Planning Stage Structural Report

150 Day Street

Prepared for UOL / 20th March 2025

Issue: Revision 2

1 L20 PLAN
RS_200 1:200

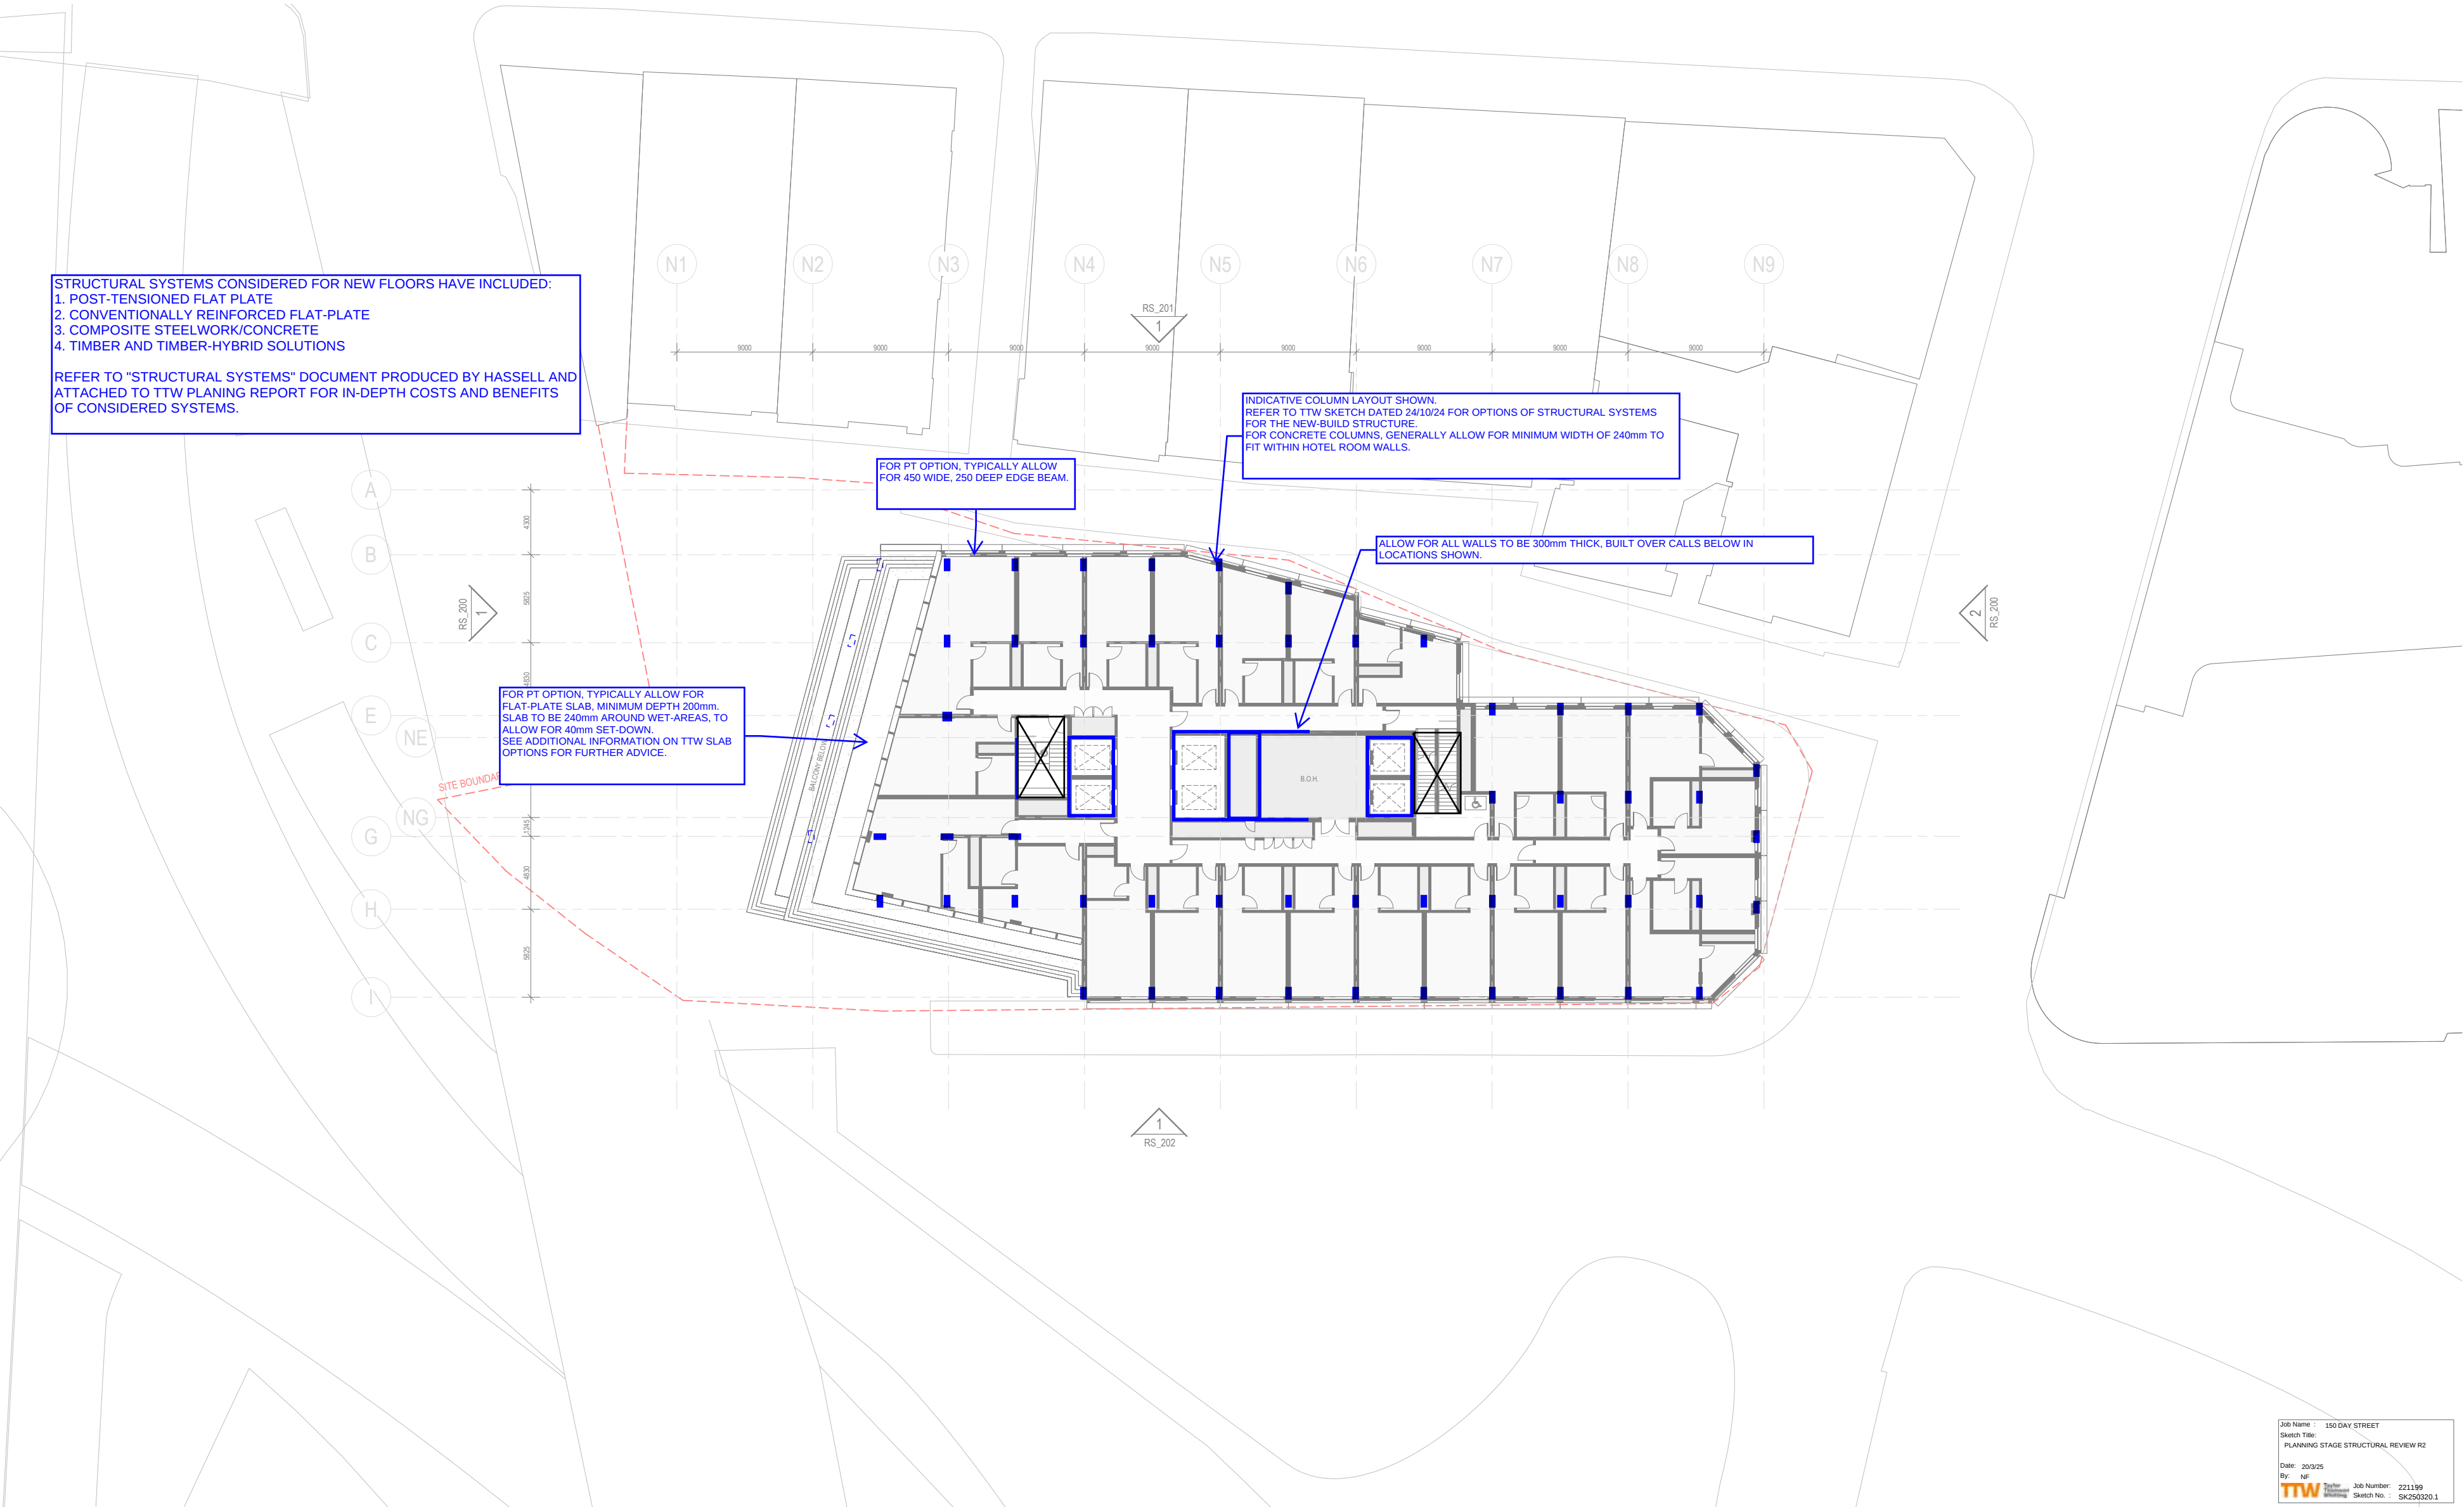
INDICATIVE COLUMN LAYOUT SHOWN.
REFER TO TTW SKETCH DATED 24/10/24 FOR OPTIONS OF STRUCTURAL SYSTEMS FOR THE NEW-BUILD STRUCTURE.
FOR CONCRETE COLUMNS, GENERALLY ALLOW FOR MINIMUM WIDTH OF 240mm TO FIT WITHIN HOTEL ROOM WALLS.

FOR PT OPTION, TYPICALLY ALLOW FOR 450 WIDE, 250 DEEP EDGE BEAM.

1 L21 PLAN
RS_200 1:200

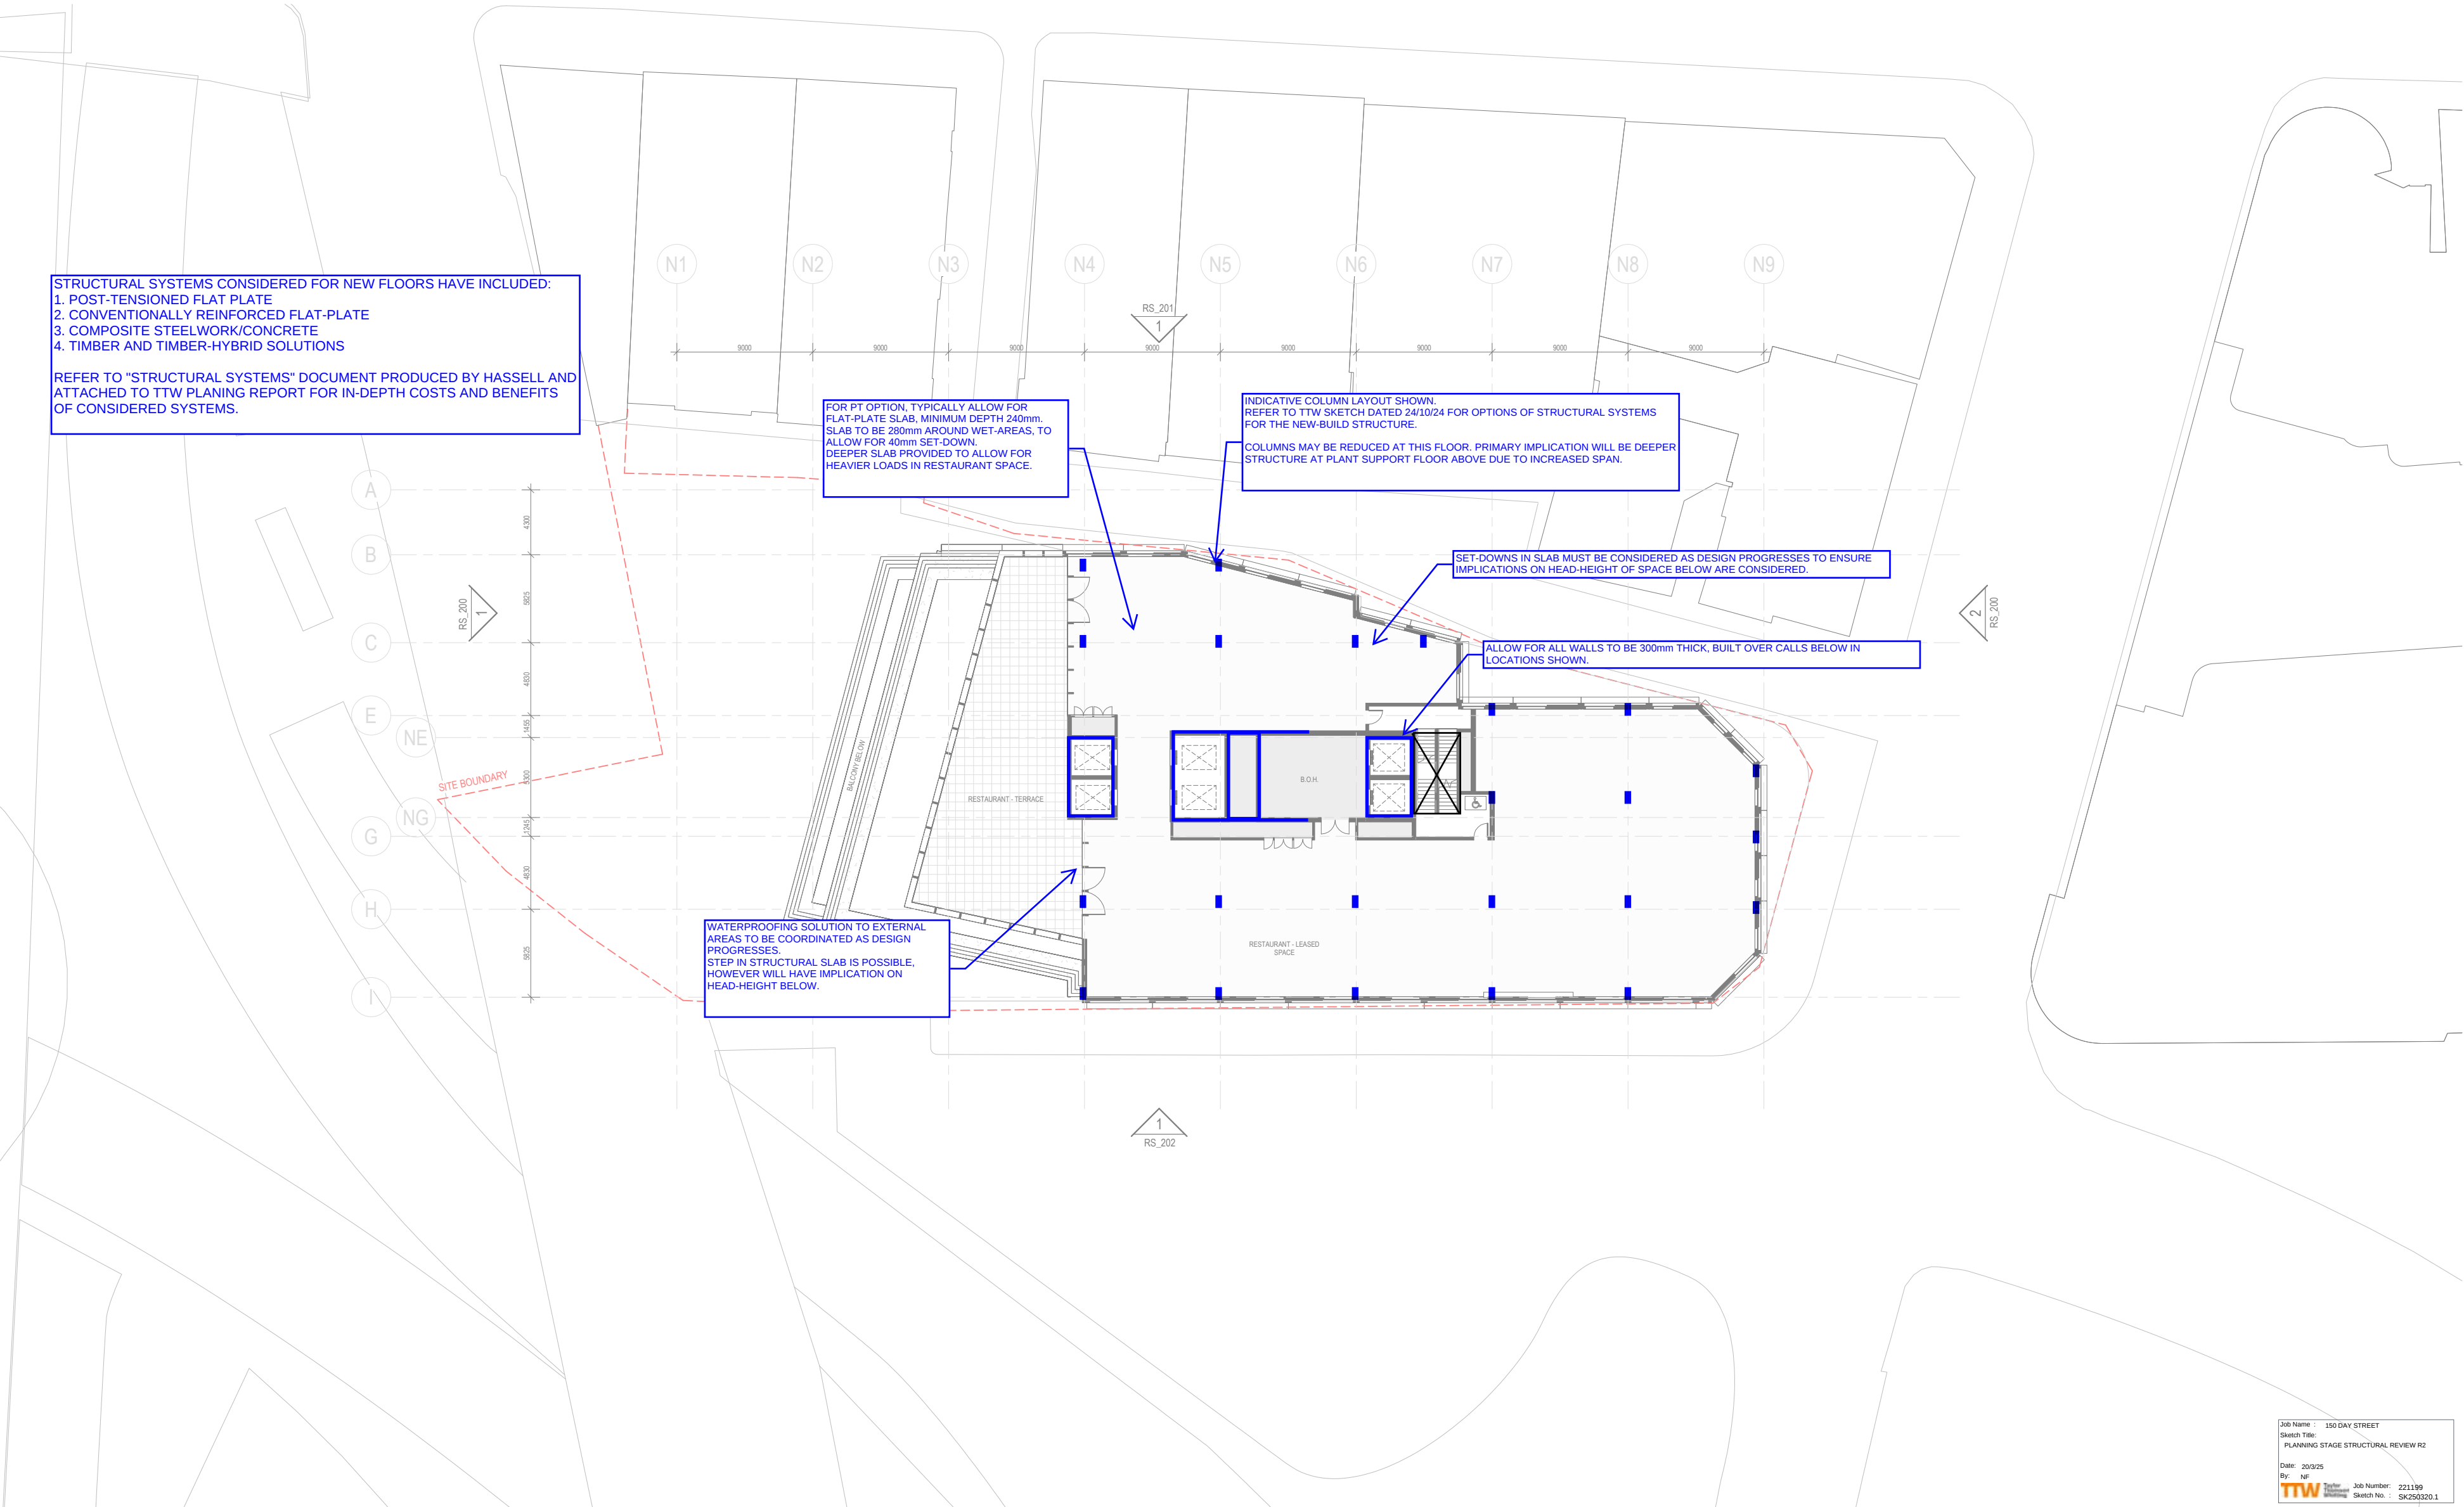
FOR PT OPTION, TYPICALLY ALLOW FOR FLAT-PLATE SLAB, MINIMUM DEPTH 240mm. SLAB TO BE 280mm AROUND WET-AREAS, TO ALLOW FOR 40mm SET-DOWN. DEEPER SLAB PROVIDED TO ALLOW FOR HEAVIER LOADS IN RESTAURANT SPACE.

INDICATIVE COLUMN LAYOUT SHOWN. REFER TO TTW SKETCH DATED 24/10/24 FOR OPTIONS OF STRUCTURAL SYSTEMS FOR THE NEW-BUILD STRUCTURE.

COLUMNS MAY BE REDUCED AT THIS FLOOR. PRIMARY IMPLICATION WILL BE DEEPER STRUCTURE AT PLANT SUPPORT FLOOR ABOVE DUE TO INCREASED SPAN.
